## STAFF REPORT ADDENDUM II

APPLICATION PRC A-502-02  
WAIVER #15797-WPFM-001-1

### HUNTER MILL DISTRICT

**APPLICANT:** Fairways I and Fairways II Residential, LLC

Fairways West

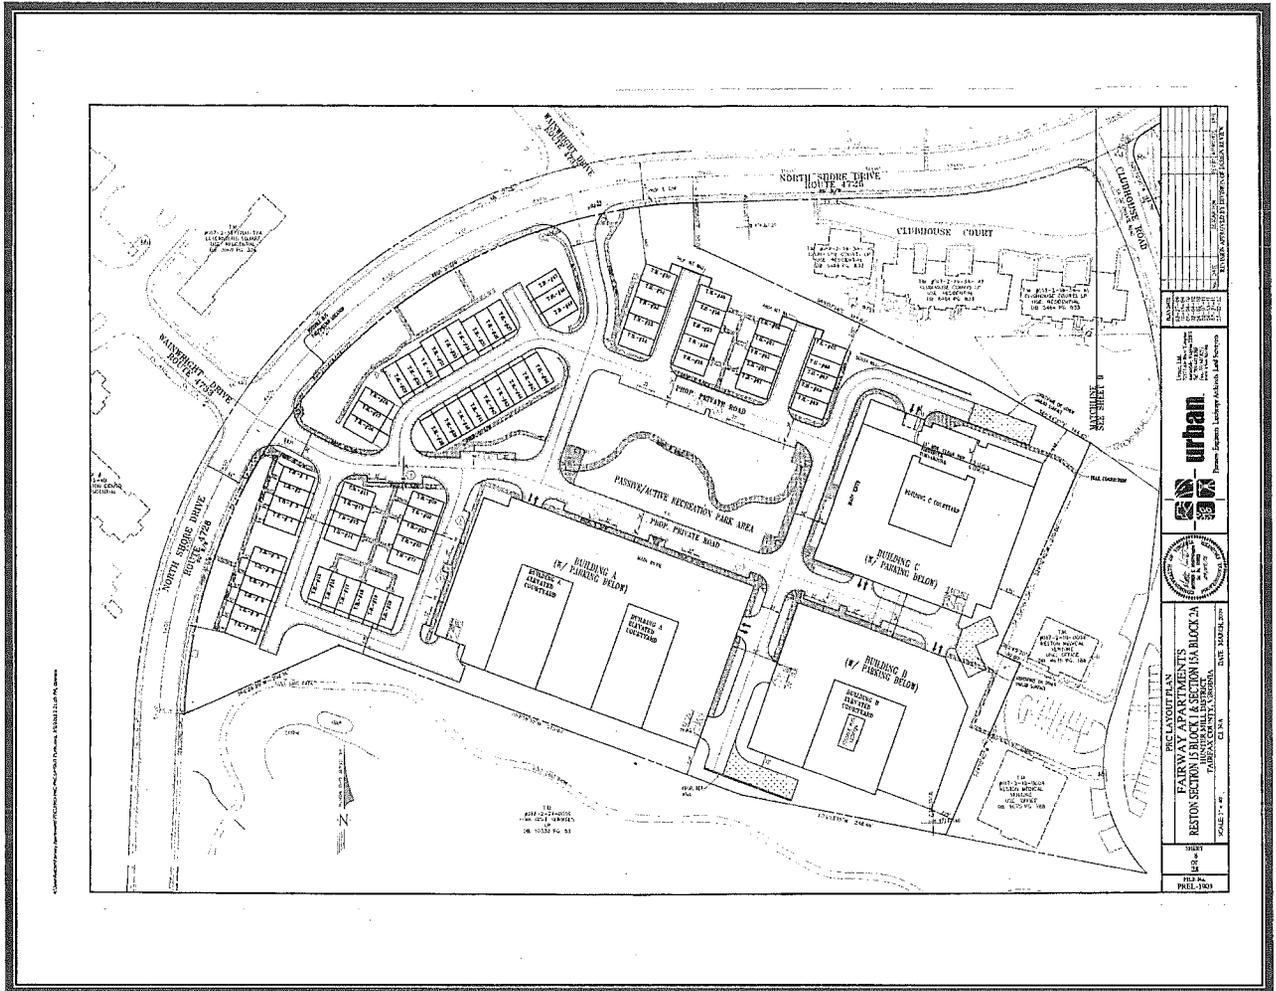
The revised PRC Plan depicts three multifamily buildings on this portion of the site rather than two as previously shown. The building previously shown as Building A on the PRC plan has been broken up into two buildings (Building A and Building B). The two buildings cover approximately the same area as the previously shown Building A. A private street is shown to extend between the two buildings providing access to the loading areas for both buildings and a garage entrance on the east side of Building A. The building previously shown as Building B is now designated as Building C on the revised PRC Plan. In addition, the design for Buildings A & B (previously Building A) has been revised to propose a podium style construction with parking provided below the proposed buildings rather than the building being wrapped around the parking garage. As a result of the podium style construction, the maximum height for Buildings A & B is shown to be 84 feet, 11 inches rather than 75 feet as previously shown. Also, a slight modification is shown to the alignment

of three of the proposed single-family attached units in the western portion of this section of the site.

Fairways East

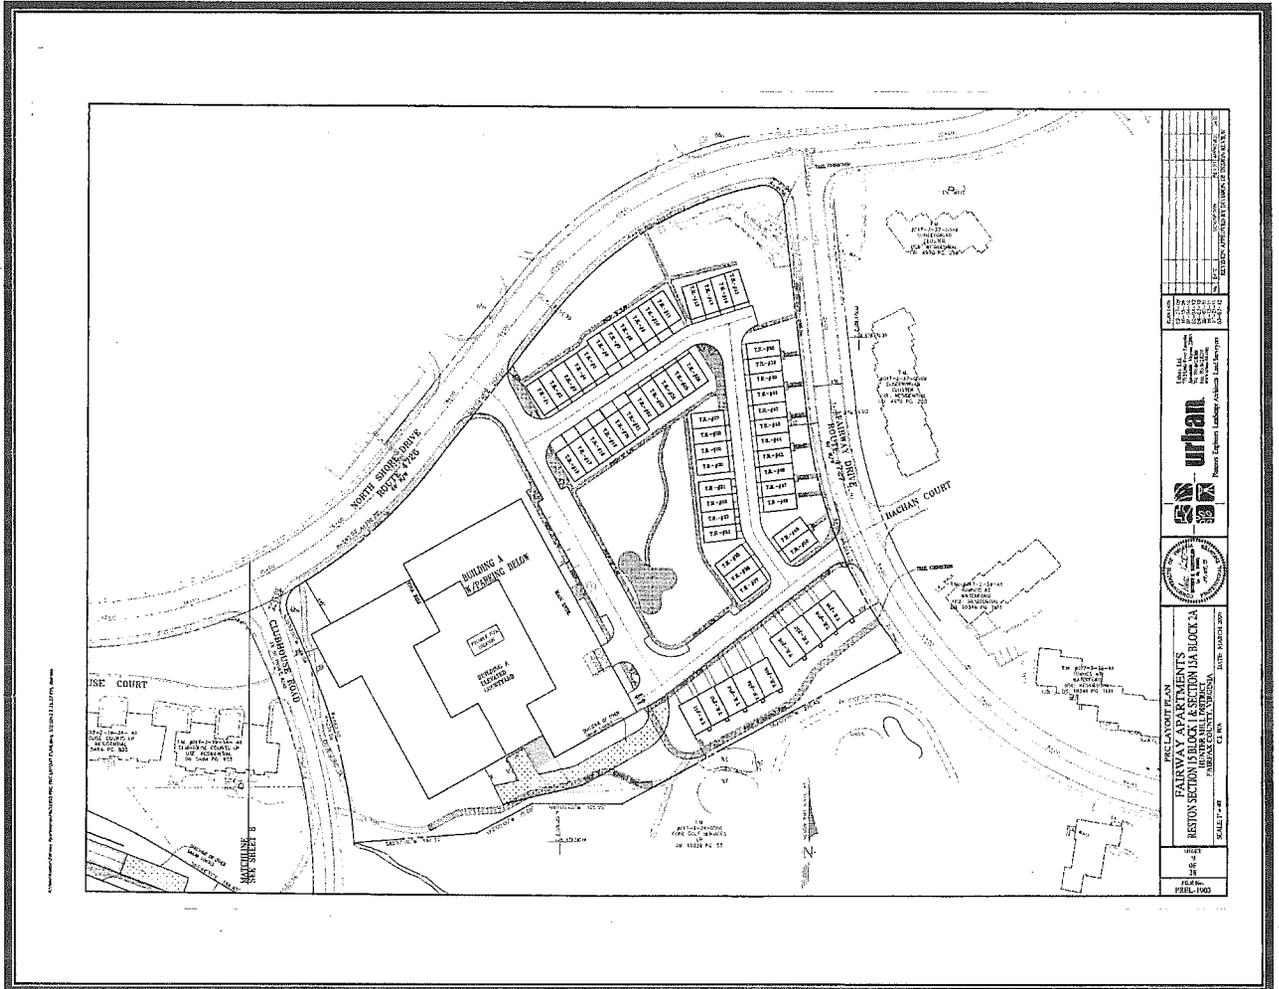
With the revised PRC Plan, the design of Building A on the eastern portion of the site has also been revised to propose podium style construction with parking provided below the proposed building rather than the building being wrapped around the parking garage. The proposed maximum height for Building A is 59 feet, 11 inches. Additionally, slight modifications are shown to the alignment of some of the proposed single-family attached units in this section of the site.

<p>SWM AND BMP PLAN: OPTION B <b>FAIRWAY APARTMENTS</b> RESTON SECTION IS BLOCK 1 &amp; SECTION 15A BLOCK 2A HUNTER MILL DISTRICT FAIRFAX COUNTY, VIRGINIA</p> <p style="text-align: right;">DATE: MARCH, 2008 CL = 7</p>							
<p>SHEET 11 OF 28</p> <p style="text-align: right;">FILE NO: PREL-1903</p>

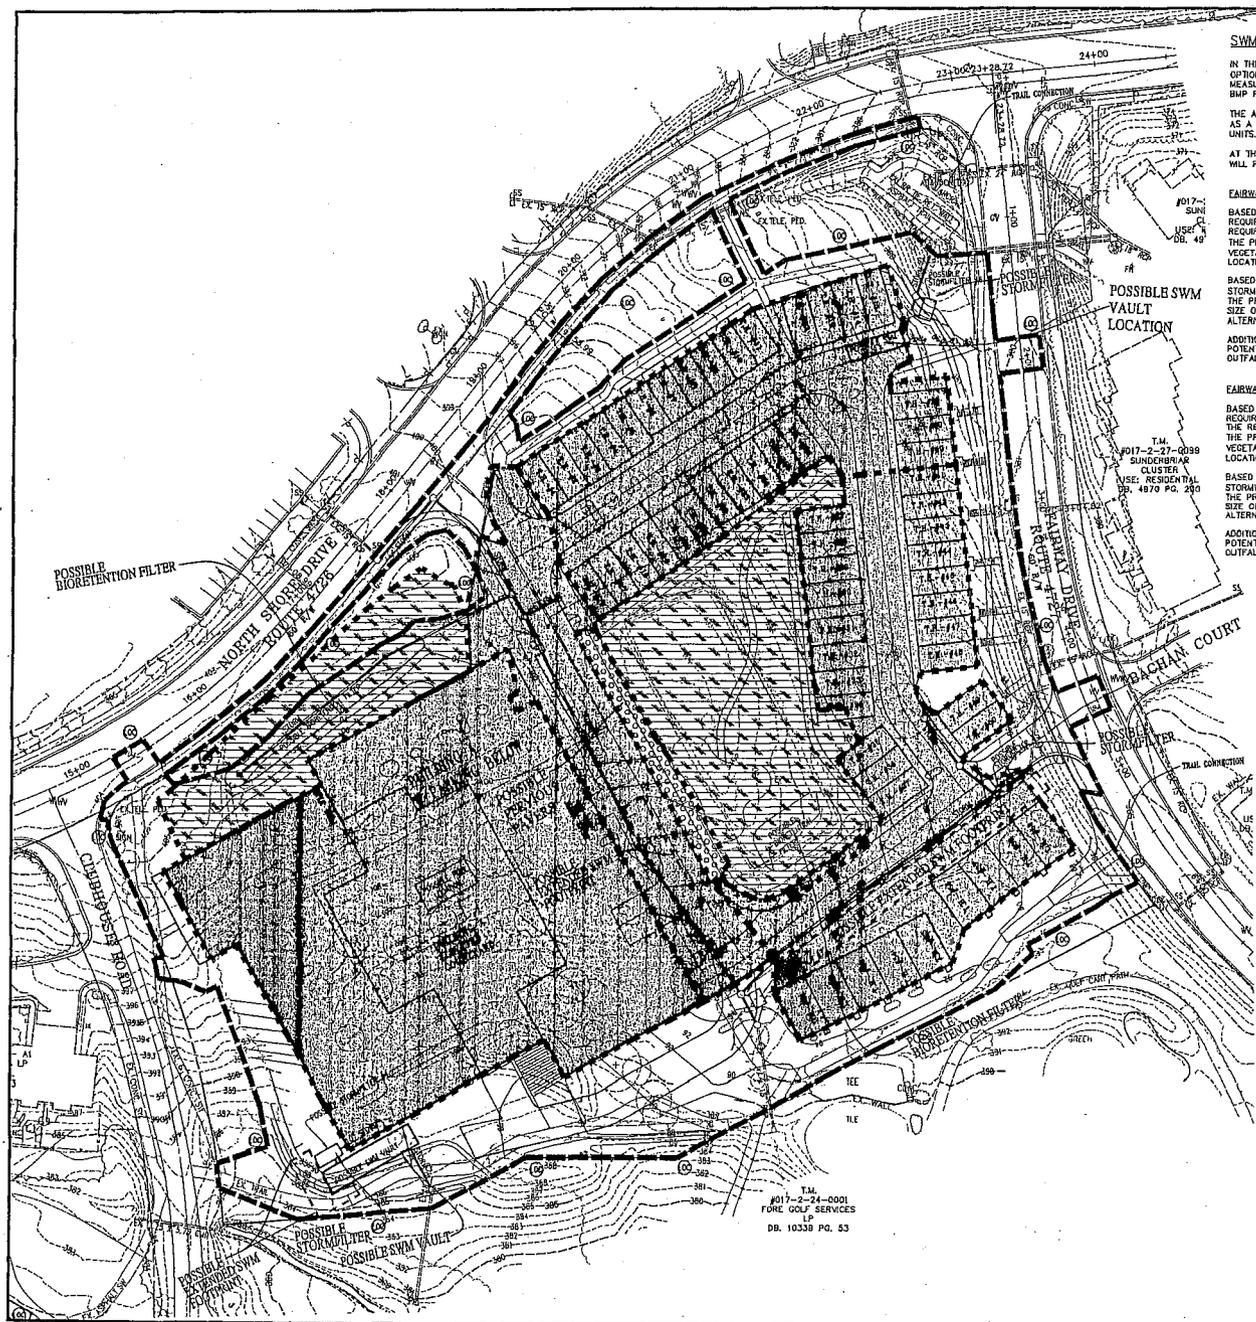
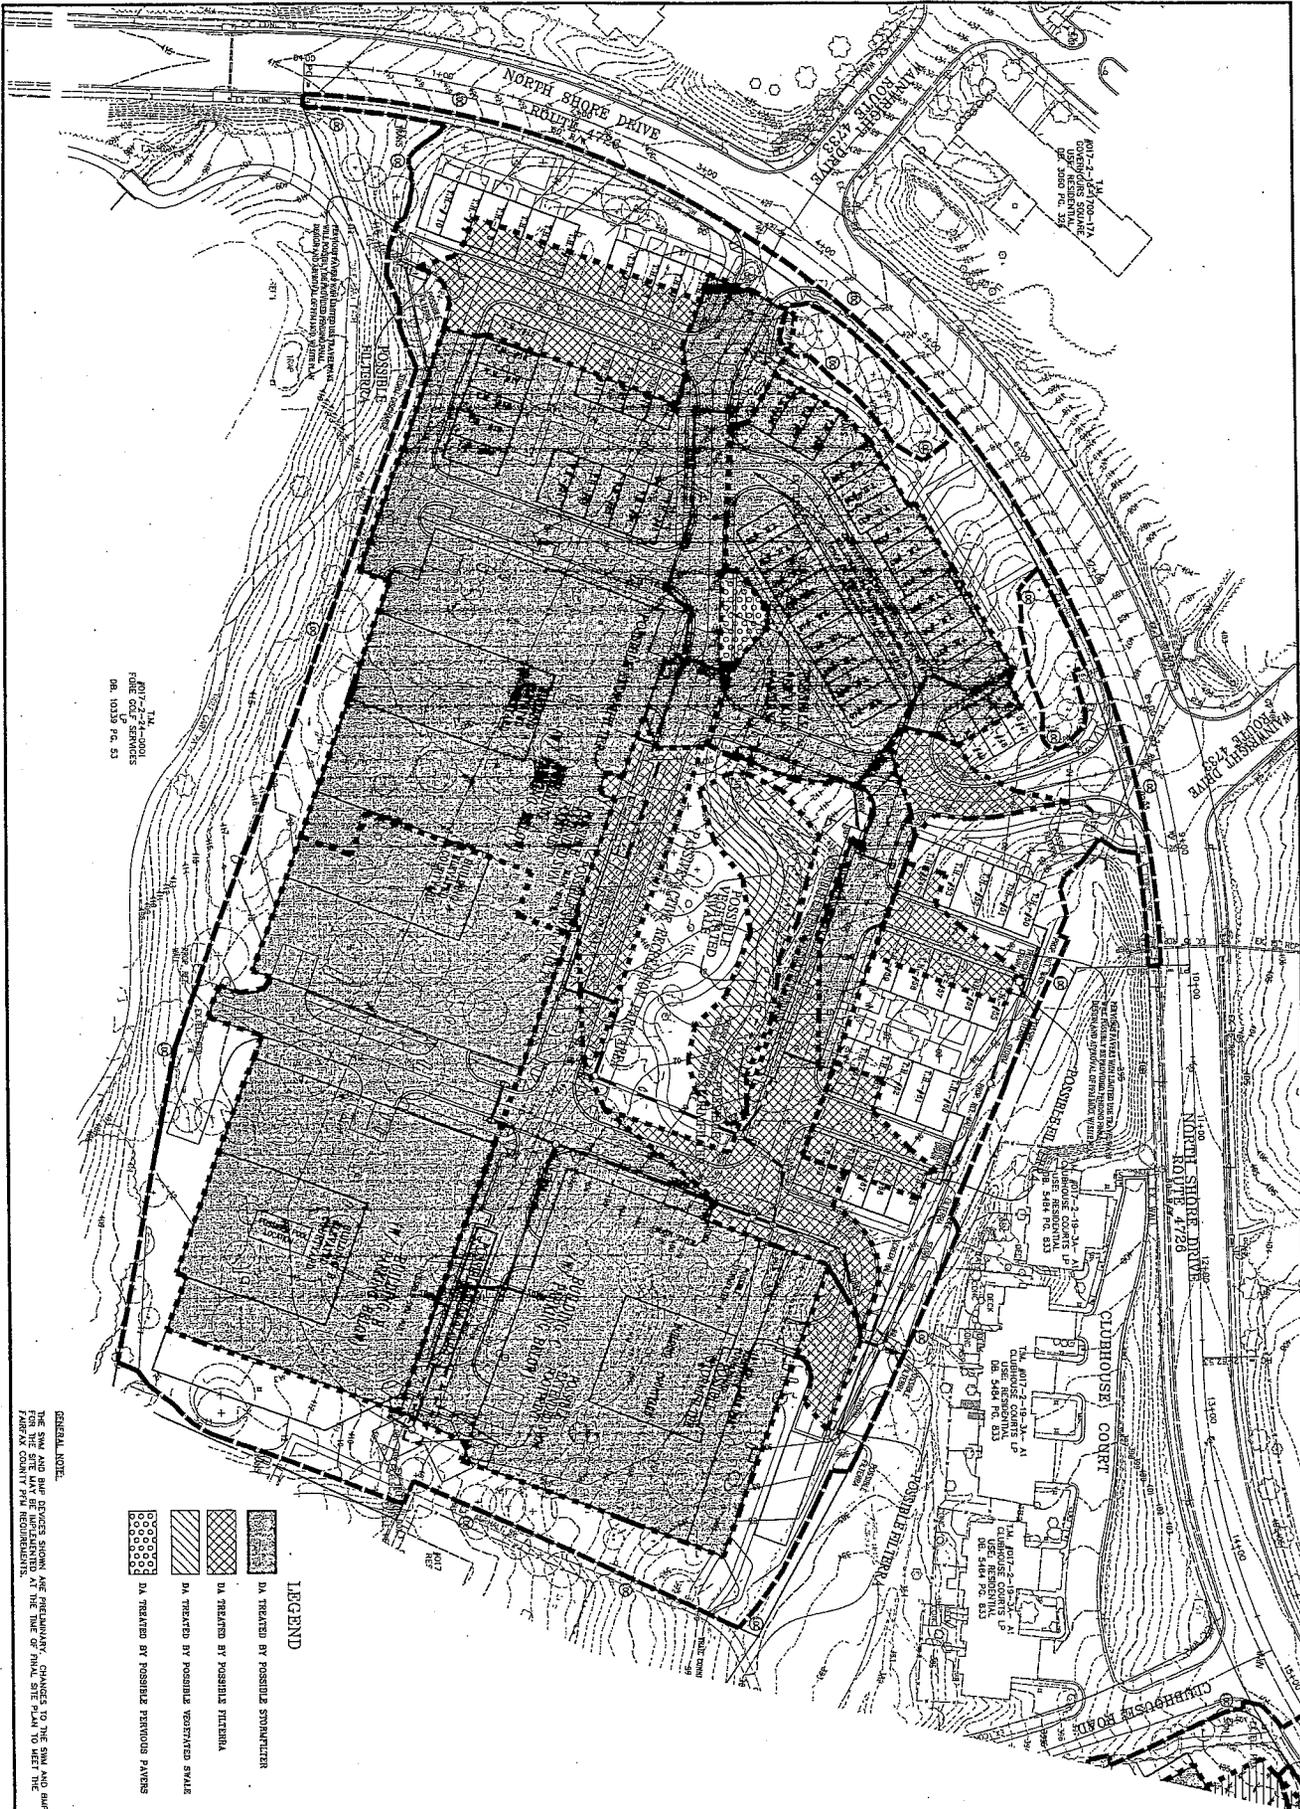
We have reviewed the referenced submission for consistency with Section 6-0303.8 of the Public Facilities Manual (PFM) which restricts use of underground stormwater management facilities located in a residential development (Attachment B). The Board of Supervisors (Board) may grant a waiver after taking into consideration possible impacts on public safety, the environment, and the burden placed on prospective property owners for maintenance. Underground stormwater management facilities located in residential developments allowed by the Board:

The property owner feels the underground storage may be necessary should the owners of the downstream wet ponds not permit the development to use the ponds or should there be inadequate outfall between the site and the ponds. Rights-of-way to correct inadequate outfall between the site and the ponds may be difficult to obtain. The owner would like the ability to use on-site detention to meet the PFM's detention and adequate outfall requirements and has proposed this scenario as Option B. Up to 10 underground detention facilities have been proposed under this option; 5 vaults are located on the development plan.

Impacts on the Environment – The site is currently developed. The 2 facilities proposed for the eastern parcel would outfall into an existing piped storm drainage system. The 3 facilities proposed for the western parcel would flow into a reconstructed storm drain system and outfall into a swale adjacent to Clubhouse Court. Adequate outfall at these locations must be demonstrated before a site plan can be approved. Staff does not believe that there will be any adverse impact on the environment from the construction and maintenance of the underground facilities.

1. The underground facilities shall be constructed in accordance with the development plan and these conditions as determined by the Director of the Department of Public Works and Environmental Services (DPWES).

2. To provide greater accessibility for maintenance purposes, the underground facilities shall have a minimum height of 72 inches.
3. The underground facilities shall be constructed of reinforced concrete products only and incorporate safety features, such as including locking manholes and doors, as determined by DPWES at the time of construction plan submission.

4. The underground facilities shall be privately maintained and shall not be located in a County storm drain easement.
5. A private maintenance agreement, as reviewed and approved by the Fairfax County Attorney's Office, shall be executed and recorded in the Land Records of the County. The private maintenance agreement shall be executed prior to final plan approval.
